STAFF REPORT WEST ALLIS PLAN COMMISSION Wednesday, April 23rd 2025 6:00 PM

3. Site, Landscaping, and Architectural Design Review to convert a single-family home into a duplex, a proposed use, at 2001 S. 70th St (Tax Key No. 453-0926-000).

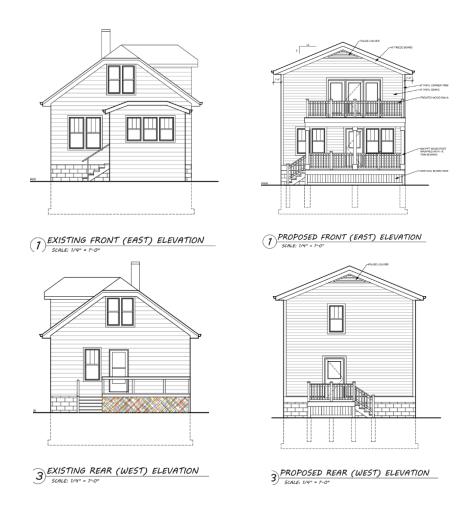
stairs and a landing. The addition will follow the existing buildout lines of the original residence. As such, it will remain compliant with all lot line regulations **except** for the requirement that structures be located at least 3 feet from the side lot line.

- The proposed addition, consistent with the form of the original residence's footprint/buildout, is planned to be 1'7" from the side lot line. Therefore, a variance from the zoning ordinances will be required for this project.
- As part of the staff recommendation, before the applicant may obtain a building permit,
 Board of Appeals consideration and approval will be required.

Recommendation: Approval of the Site, Landscaping, and Architectural Design Review to convert a single-family home into a duplex, a proposed use, at 2001 S. 70th St (Tax Key No. 453-0926-000) subject to an application submitted to the Board of Appeals for an area variance to allow a side lot setback of 1'7" instead of the current standard of 3'.

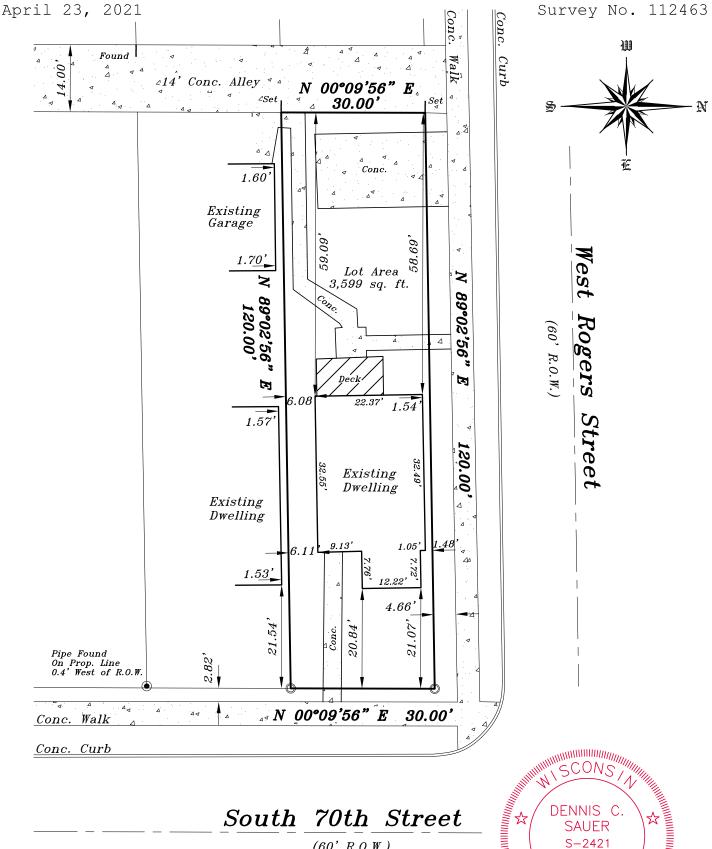
- Consideration of a clipped gable roof features on east and west elevations.
- Color and finish details of the building exterior siding, trim, and porch/deck railings is recommended.
